**NUCLEAR MANAGEMENT COMPANY, LLC
PALISADES NUCLEAR PLANT, DOCKET 50-255, LICENSE DPR-20
CORRECTION TO FIRE PROTECTION EXEMPTION REQUEST**

**Corrected Figure 3B of Attachment 15
To Exemption Requests Dated July 20, 1984 and June 19, 1985**

PALISADES PLANT FIGURE 3B ATTACHMENT 15

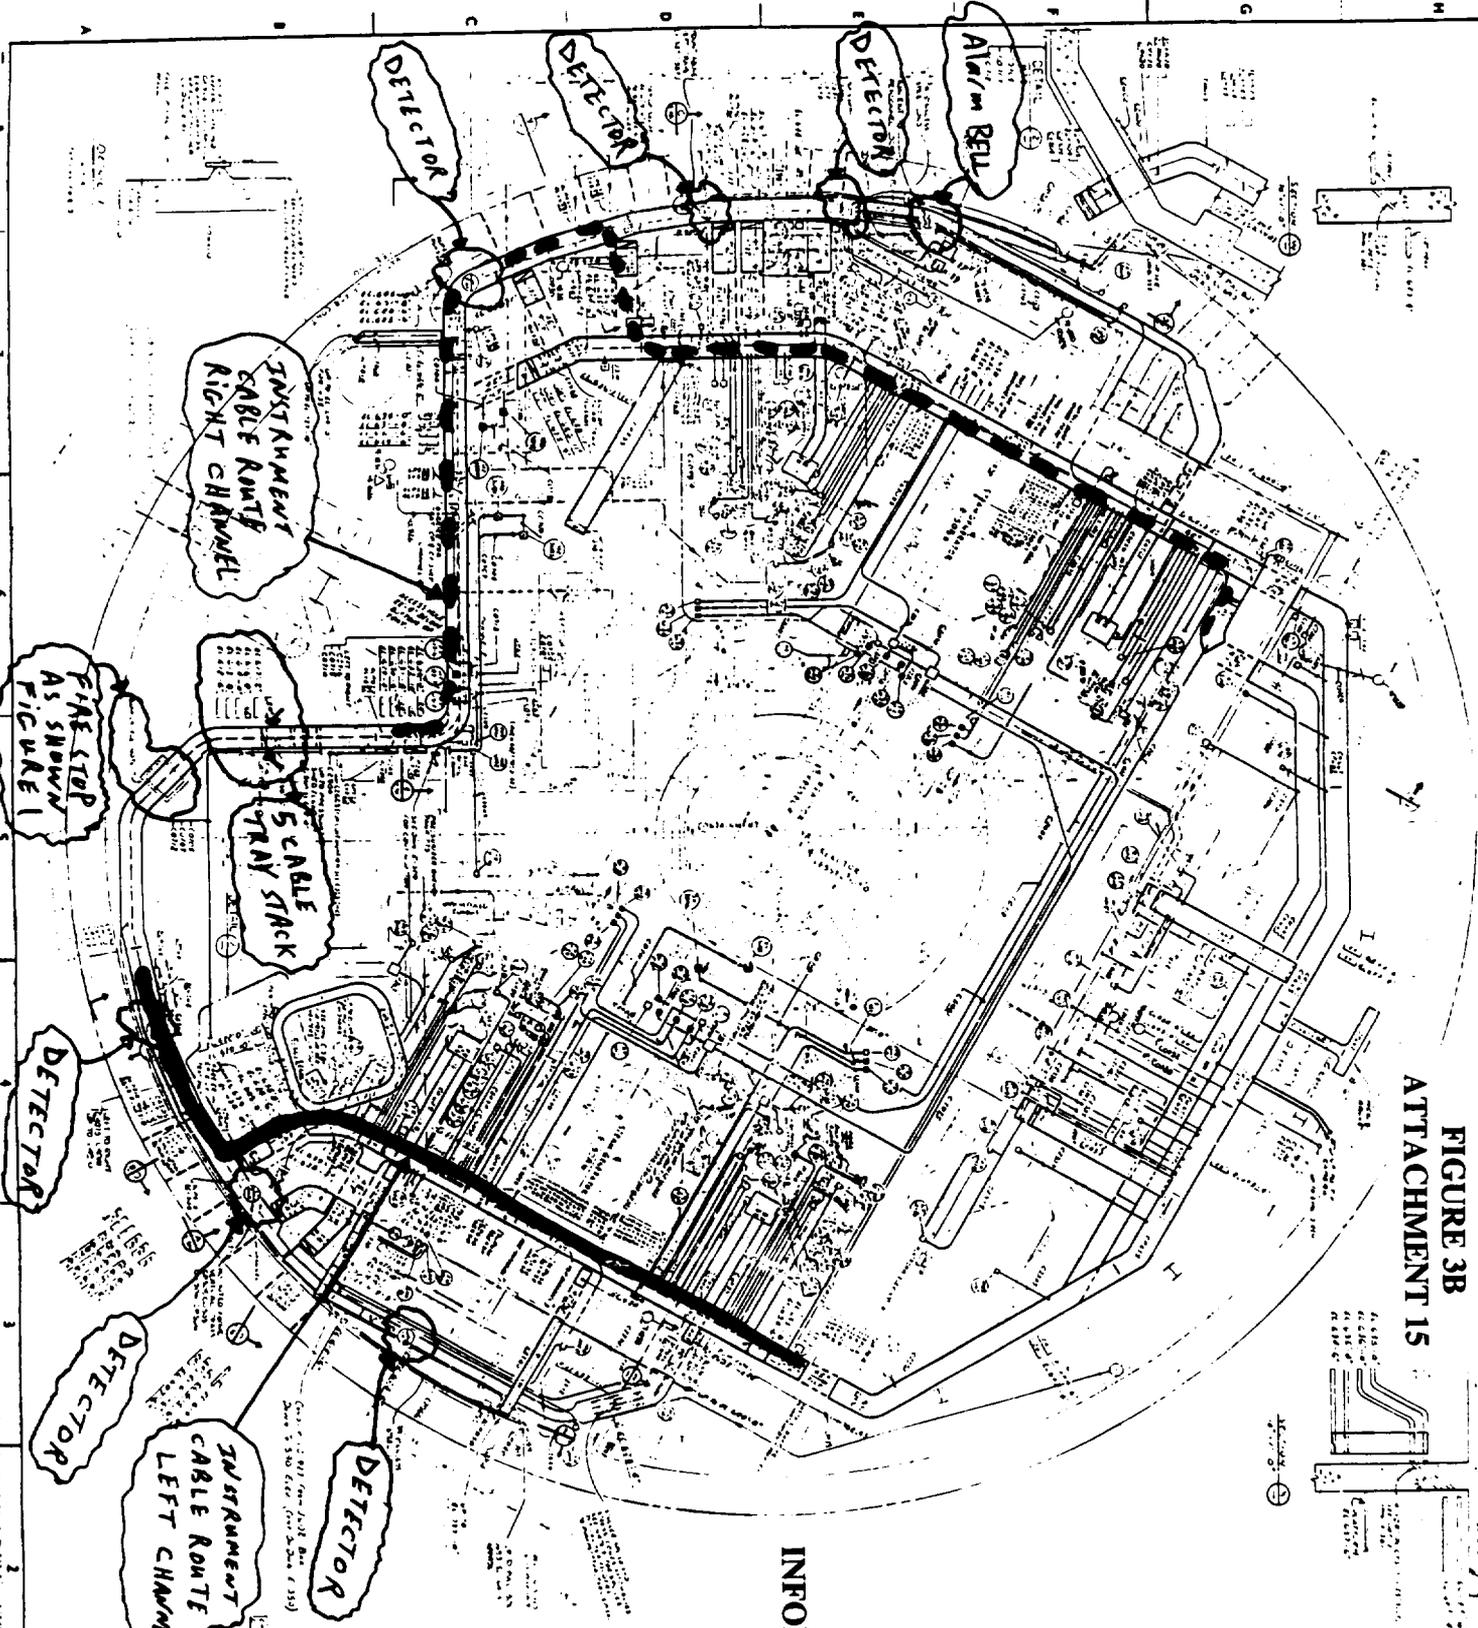
Figure 3B to Attachment 15 of the July 20, 1984 and June 19, 1985 submittals provided information that included identification of the location of fire detectors in the containment 607' elevation area. Four fire detectors were originally, and incorrectly, denoted in the area for the right channel instrument cable route. NMC is enclosing a corrected Figure 3B which denotes three fire detectors. These fire detectors are installed in areas of cable concentration. The previously identified fourth detector, labeled "alarm bell," is a local alarm that is energized upon smoke detector actuation in the containment. There are no cable concentrations between the alarm bell and the adjacent fire detector. NMC has determined that the remaining three smoke detectors are adequate to provide fire detection in the areas of cable concentration as stated in the NRC exemption dated July 23, 1985.

Enclosure 1 provides the revised Figure 3B of Attachment 15 to the exemption requests dated July 20, 1984 and June 19, 1985.
